ENGINE INDICATING - ENGINE - INDICATING - PROVIDE PERMANENTLY ATTACHED WASHERS TO BRACKET AT CLIPPING POINTS CP6004 AND CP6009 - CATEGORY CODE 6 - MOD.ENG-77-0007

V2500-ENG-77-0007

SERVICE BULLETIN

Location of Loop Clamp Bracket Assemblies
Fig.1 (Sheet 1 of 2)

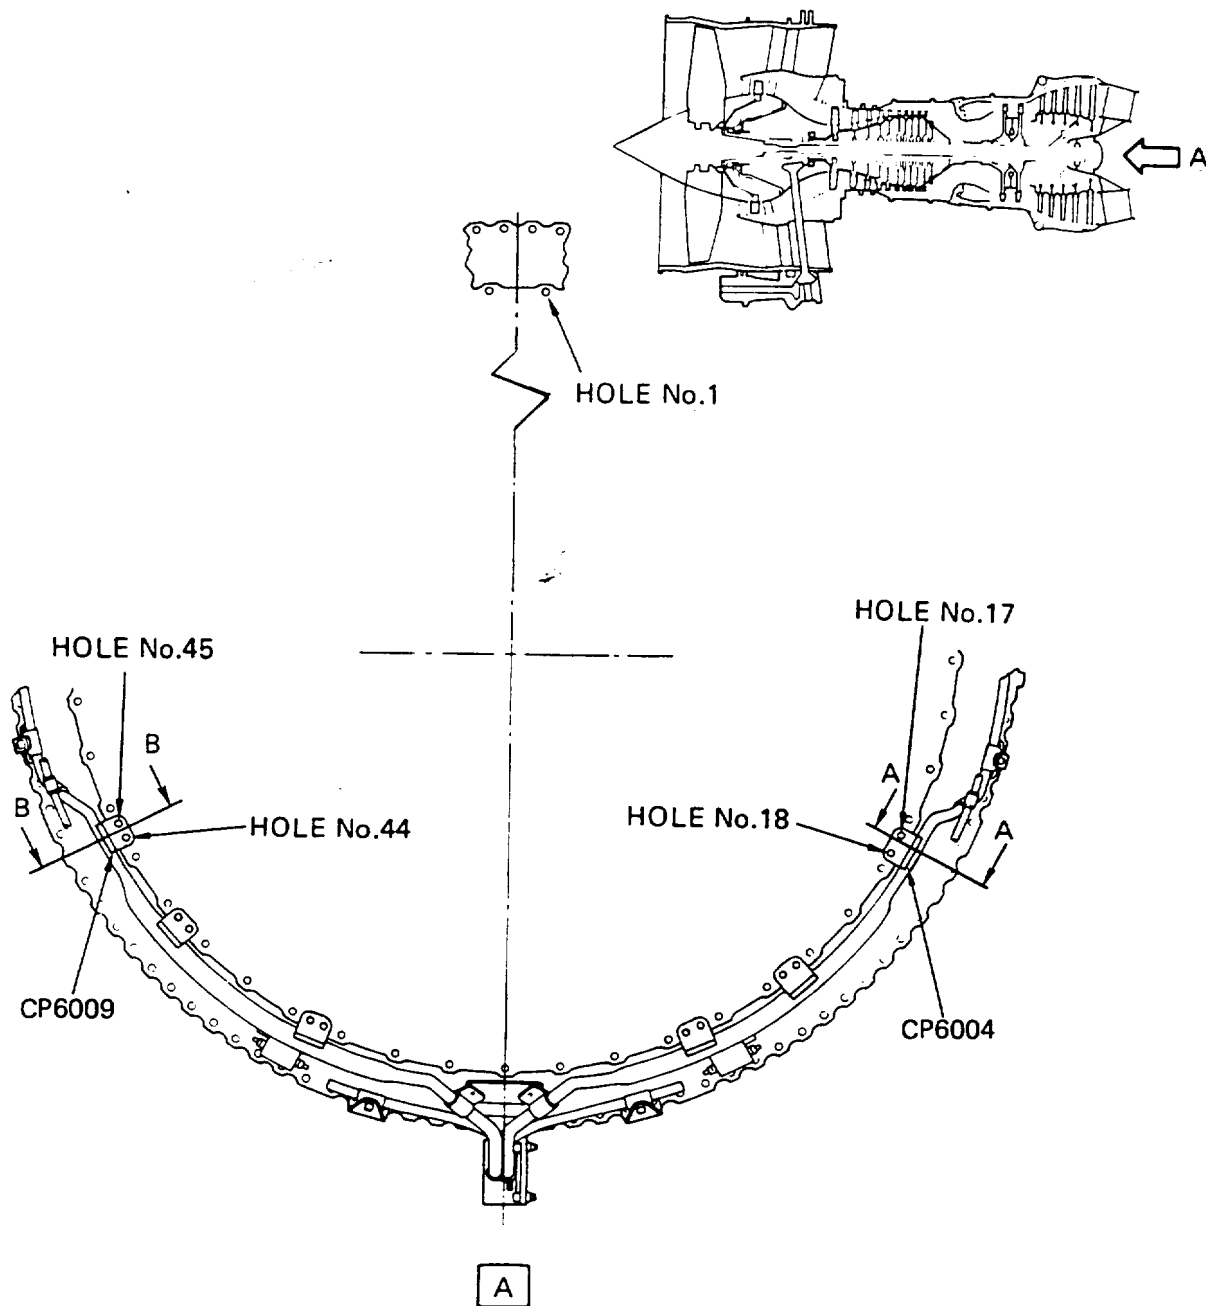
- (1) This modification installs a tack welded washer to the Loop Clamp Bracket Assembly at each of the flange "FT" locations specified, to obtain the desired clearance between the EGT Harness and the TEC Stiffening Rib.

- (2) Install the 2A1763-01 Loop Clamp Bracket Assemblies (2 off) at clipping points CP6004 and CP6009 on Flange "FT" and connect the EGT Harness as follows:

- (a) Lubricate the threads of the 4W2386 Screws (4 off) and 4W0002 Nuts (4 off) with CoMat 10-039 Engine Oil.
 - (b) Put one of the Loop Clamp Bracket Assemblies (2 off) at the No's.17 and 18 hole locations on Flange "FT", clipping point CP6004. Refer to Figure 1.

- (c) Install two of the 4W2386 Screws and the 4W0002 Nuts and tighten them with your hand.
 - (d) Do steps (2)(b) and (c) again at the location of the hole No's.44 and 45 on Flange "FT", clipping point VCP6009. Refer to Figure 1.

- (f) Lubricate the threads of the 4W0001 Nuts (2 off) with CoMat 10-039 Engine Oil.
 - (g) Connect the Loop Clamp to the Loop Clamp Bracket Assembly at hole location No.17 and 18 on Flange "FT", clipping point CP6004. Refer to Figure 1.

- (h) Install one of the 4W0001 Nuts and tighten it with your hand.
 - (i) Do steps (2)(g) and (h) again and install one Loop Clamp at the location of hole No's.44 and 45 on Flange "FT", clipping point CP6009. Refer to Figure 1.
